Product Change Notification

Product Change Notification number 100015466

Subject of change Product label update for basicDIM Wireless modules

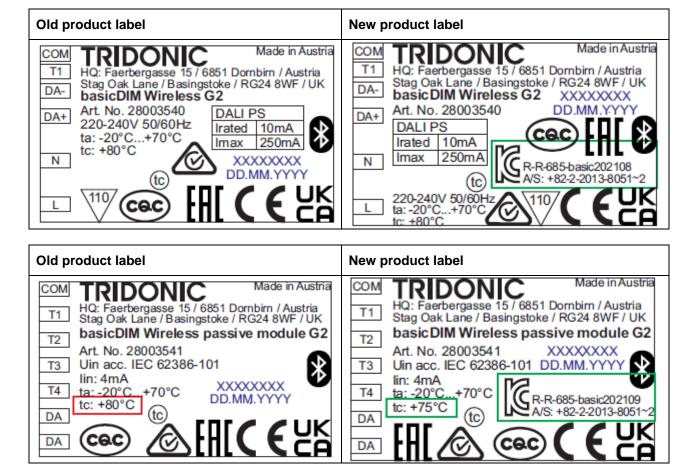
The product label of the affected products has been updated and the following certification mark has been added:

Certification mark KC:

In addition to the certification mark the Tc temperature for article 28003541 has been corrected from 80°C to 75°C as well as on the product label and in the data sheet.
